## COMMUNITY UNIT PLAN DP-88

**RE: CUP2022-00029 – City CUP Adjustment to Wiedemann Business Park Community Unit Plan CUP DP-88 to adjust parcel sizes on property zoned GC General Commercial, located on the south side of East Kellogg Drive, within one-quarter mile west of South Greenwich Road.**

# WIEDEMANN BUSINESS PARK

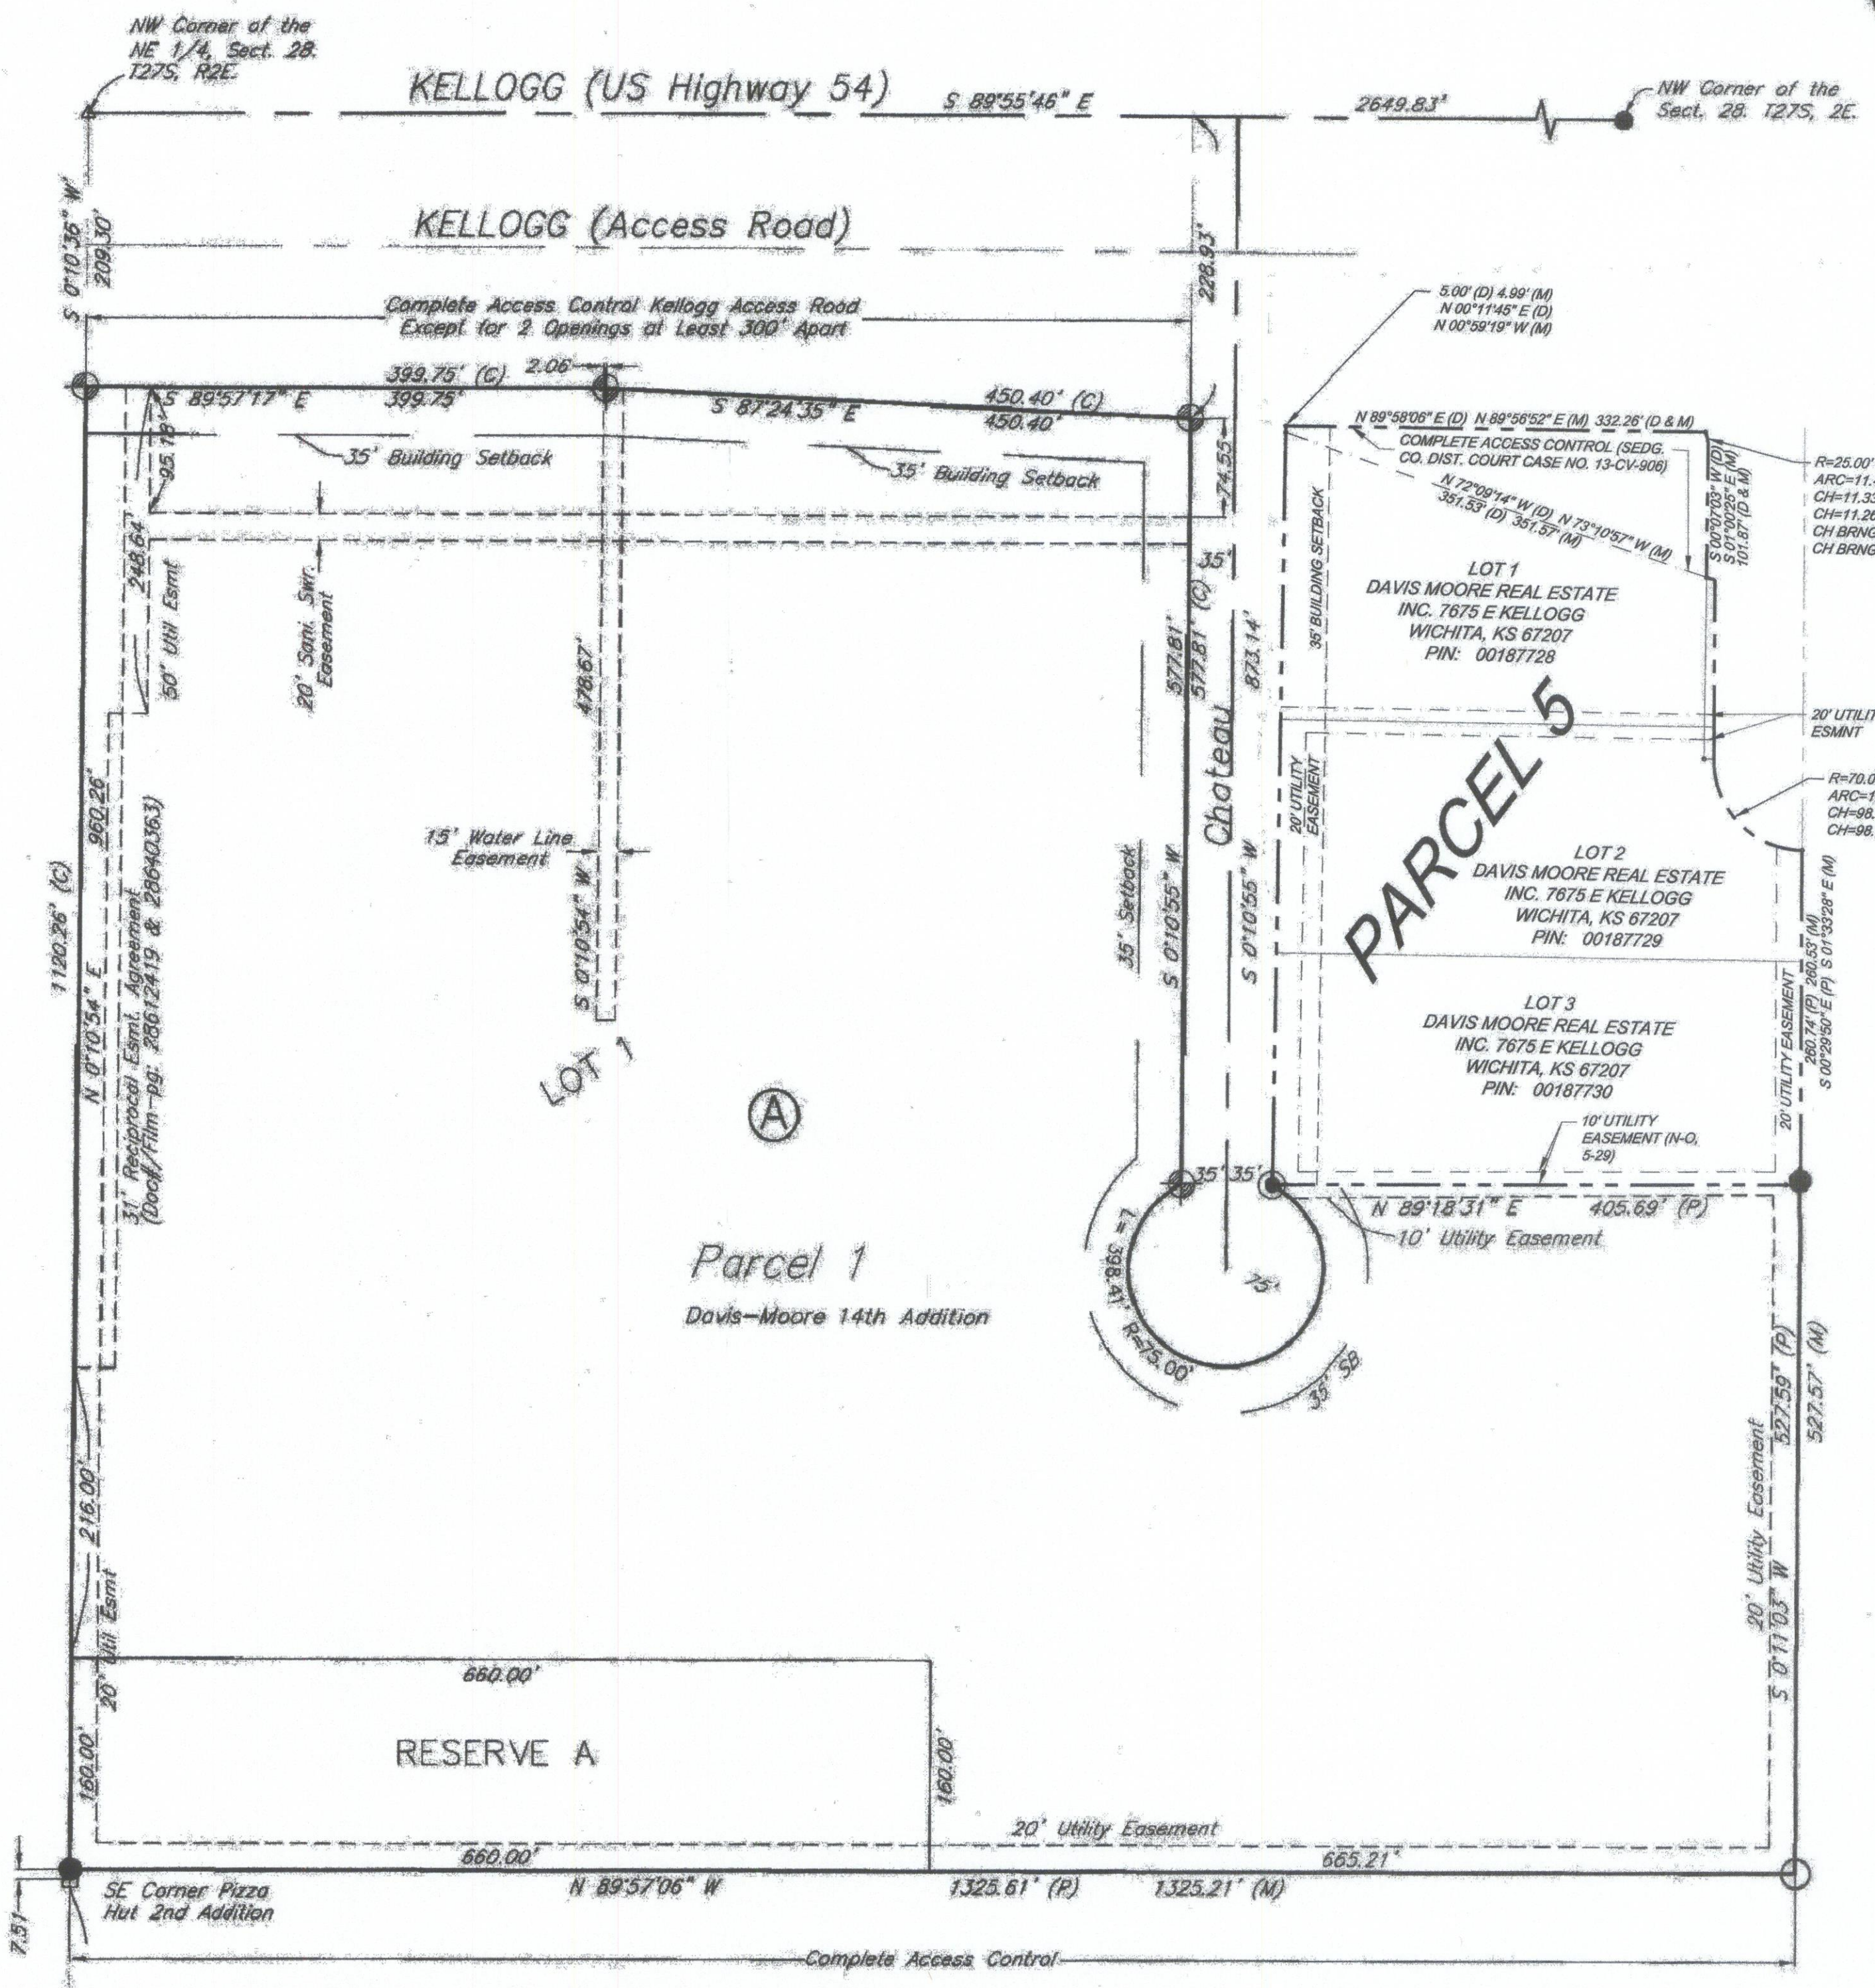
ADJUSTED 12-10-25 PER CUP2025-00040

# WIEDEMANN BUSINESS PARK COMMUNITY UNIT PLAN DP-88

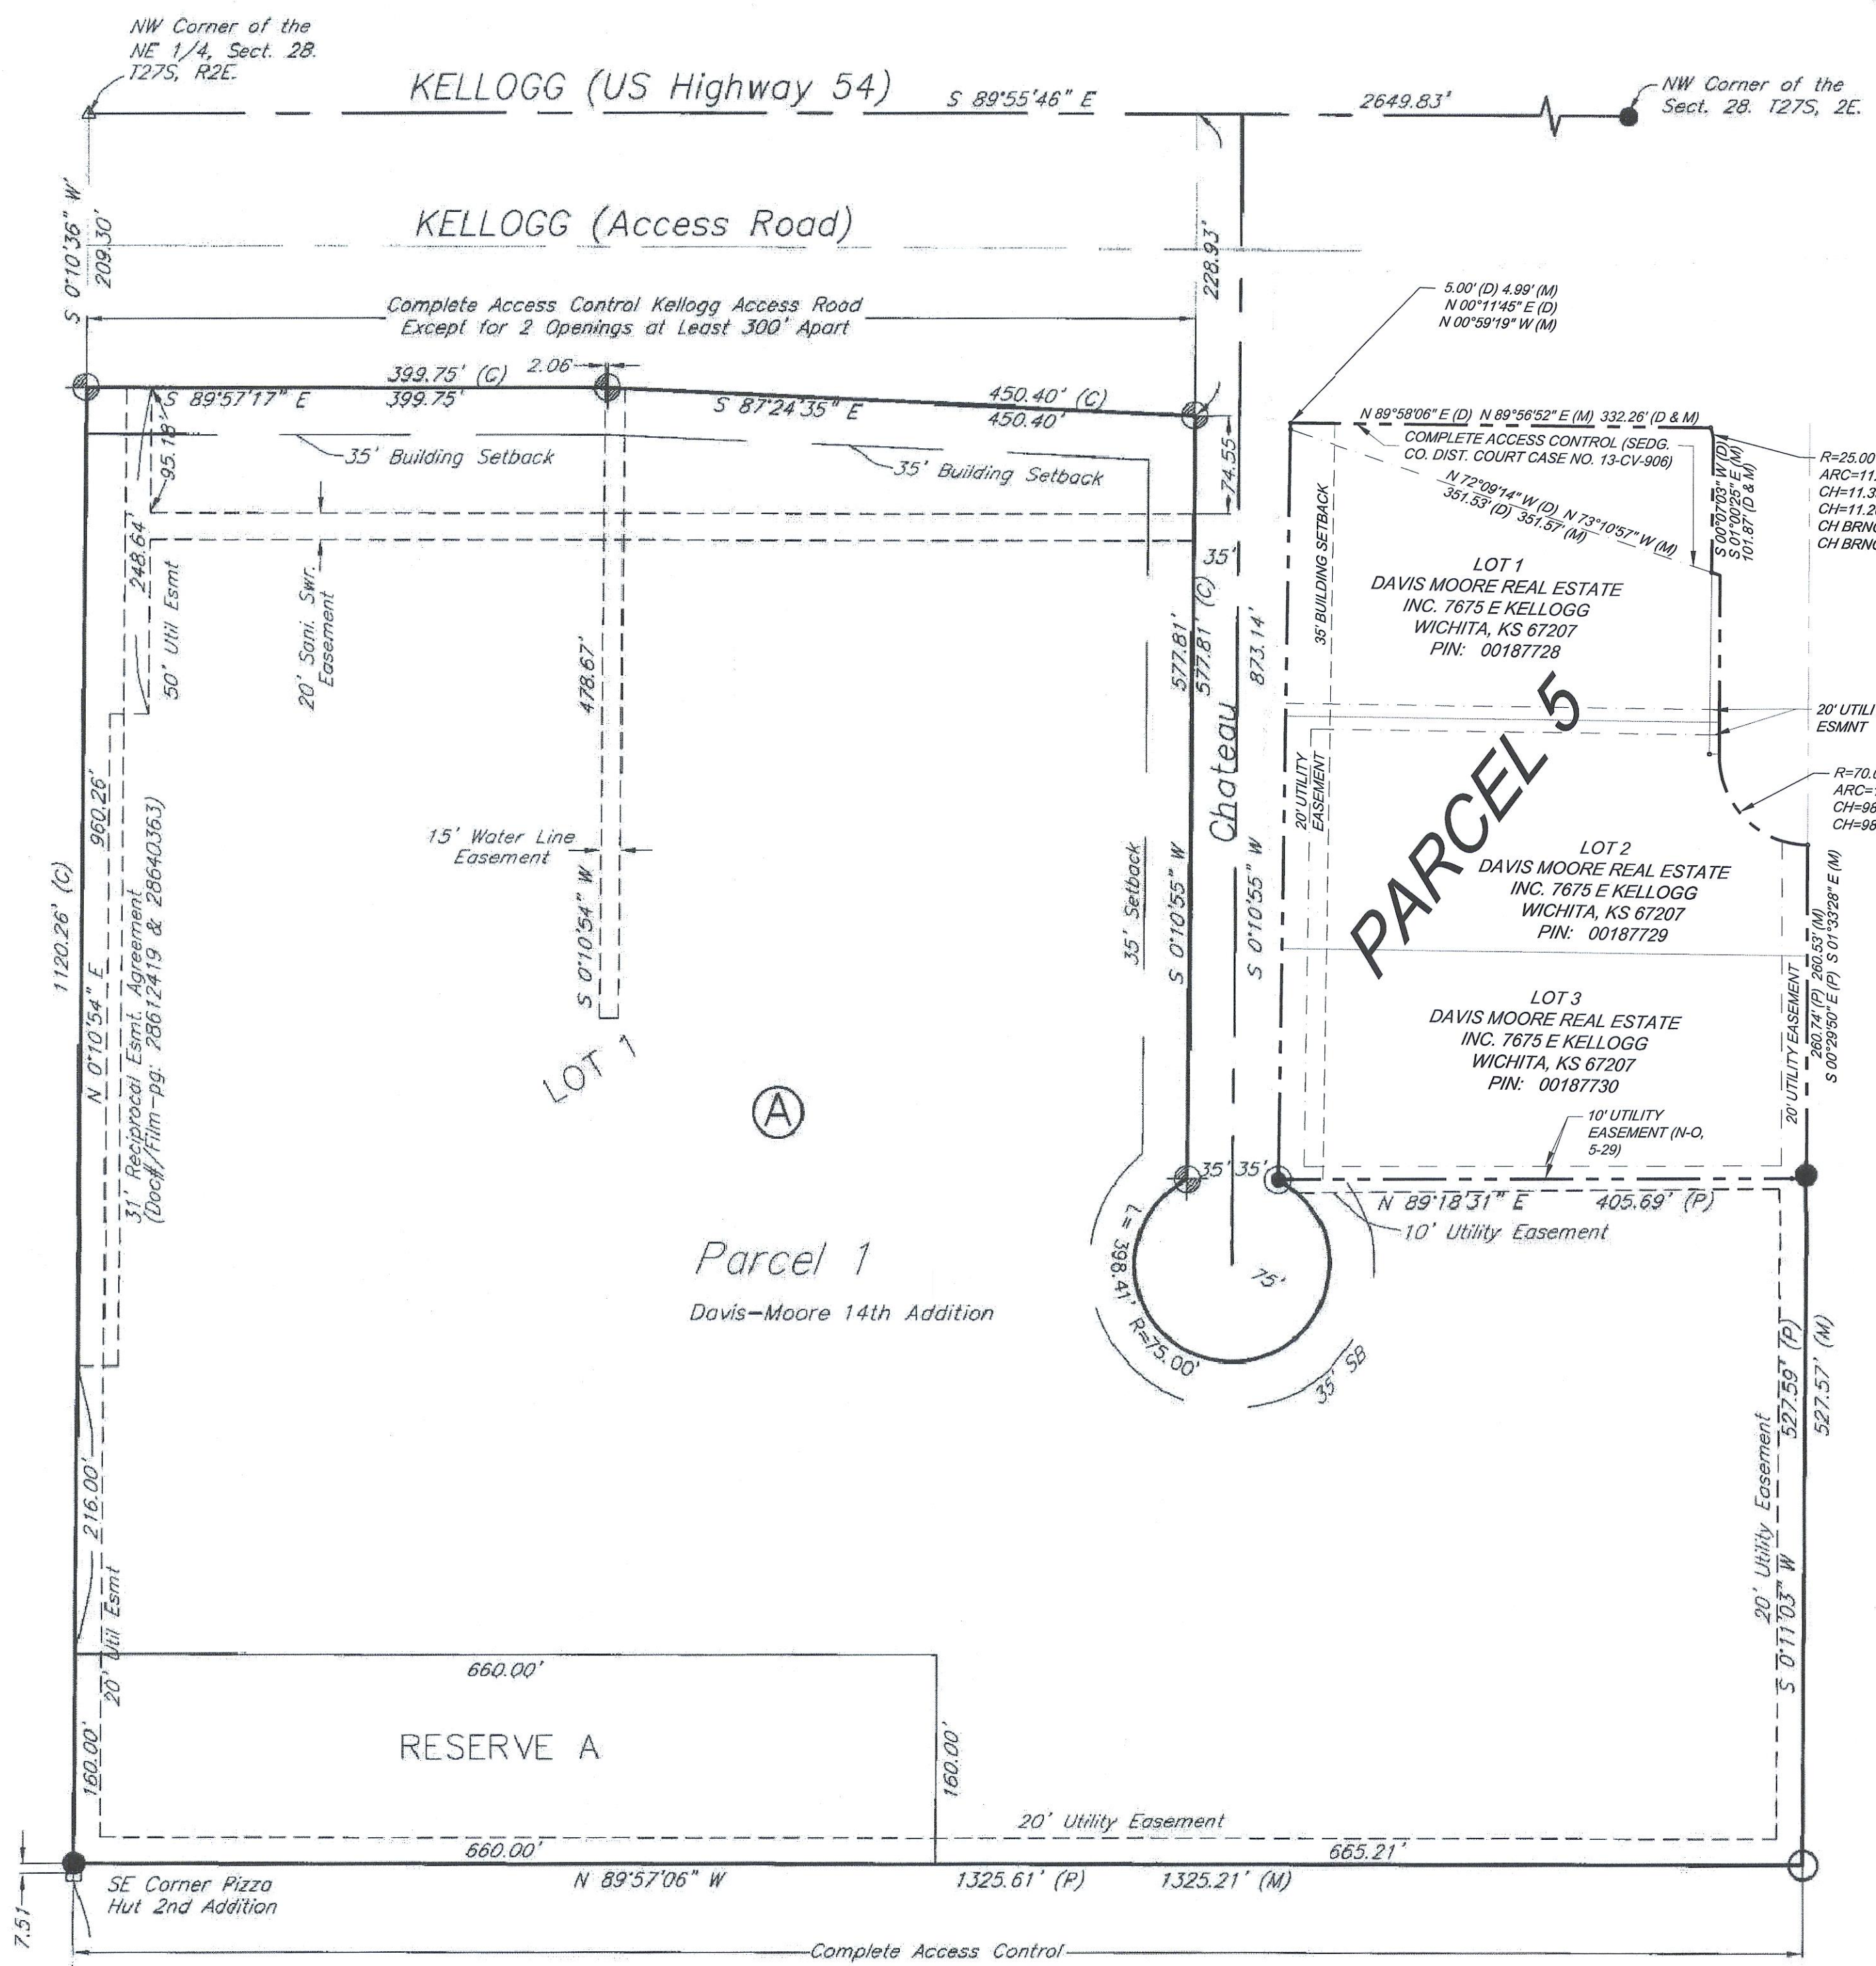
We received and reviewed your request for an Administrative Adjustment to DP-88 to alter the parcel boundary and area calculations of Parcel 5. Upon review of the Community Plan General Provision, staff found additional adjustments to outdated terminology that needs to be included in this adjustment. The following reflects the proposed modifications identified in red letters:

**Parcel 5:**

Floor Area Ratio: 45% or **99,558 sq. ft.**; 50% or **110,620 sq. ft** for warehousing or wholesale distribution.

Area = **5.08 Acres**

**General Provisions:**

#7: Screening and Landscaping: A landscaped street yard adjacent to the Kansas Turnpike shall be provided with trees, grass and shrubbery not less than ten (10) feet in width, and otherwise in compliance with the landscape ordinance. Failure to maintain the landscape street yard shall be considered a violation of the C.U.P. after a joint determination by the Director of Planning and **the Zoning Administrator.**  
~~Superintendent of Central Inspection.~~

A performance bond shall be posted with the **Zoning Administrator** ~~Superintendent of Central Inspection~~ guaranteeing the present cost of wall construction adjusted for inflation over a ten (10) year period...

- Screening and Landscaping: A landscaped street yard adjacent to the Kansas Turnpike, shall be provided with trees, grass and shrubbery not less than ten (10) feet in width, and otherwise in compliance with the landscape ordinance. Failure to properly maintain the landscape street yard shall be considered a violation of the C.U.P. after a joint determination by the Director of Planning and the Zoning Administration.

A performance bond shall be posted with the Zoning Administration, guaranteeing the present cost of wall construction adjusted for inflation over a ten (10) year period. Said bond shall be released should the property to the east be approved for a nonresidential zoning classification and shall be executed whenever the property to the east develops residentially, or at the end of the ten year period should the property remain undeveloped and zoned residentially.

**Parcel 5:**  
Permitted Uses: Same as Parcel 1  
Floor area ratio: 15% or 99,558 sq. ft., 50% or 110,620 sq. ft., for warehousing or wholesale distributors. Maximum building height: 35 feet  
Area= 5.08 Acres
